Technical product information

Topic	DTC B17B801 and/or B17B804 - evident within address 0019 and/or DTC U112300 evident in 00A5
Market area	Russische Föderation (5RU),Australia E04 Bentley rest Asia and Australia (6E04),China 796 VW Import Comp. Ltd (Vico), Beijing (6796),Germany E02 Bentley rest Europe (6E02),Japan E03 Bentley Japan (6E03),Korea, (South) E08 Bentley South Korea (6E08),United Arab Emirates E06 Bentley Middle East and Africa (6E06),United Kingdom E01 Bentley UK (6E01),United States E05 Bentley USA and rest America (6E05)
Brand	Bentley
Transaction No.	2063855/4
Level	EH
Status	Approval
Release date

DTC B17B801 and/or B17B804 - evident within address 0019 and/or DTC U112300 evident in 00A5

TPI 2063855/4 - Additional request to replace the control module (as Figure 1) in conjunction with the steering wheel

Figure 1

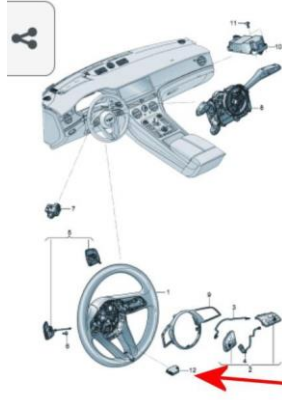
IMPORTANT: The operative must also replace the control module shown in Figure 1

2) Conduct a visual check between the original steering wheel and the replacement steering wheel to confirm all applicable components have been transferred successfully and control module replaced as shown in Figure 1

IMPORTANT: The operative must also replace the control module shown in Figure 1 - Refer to the ETKA parts catalogue
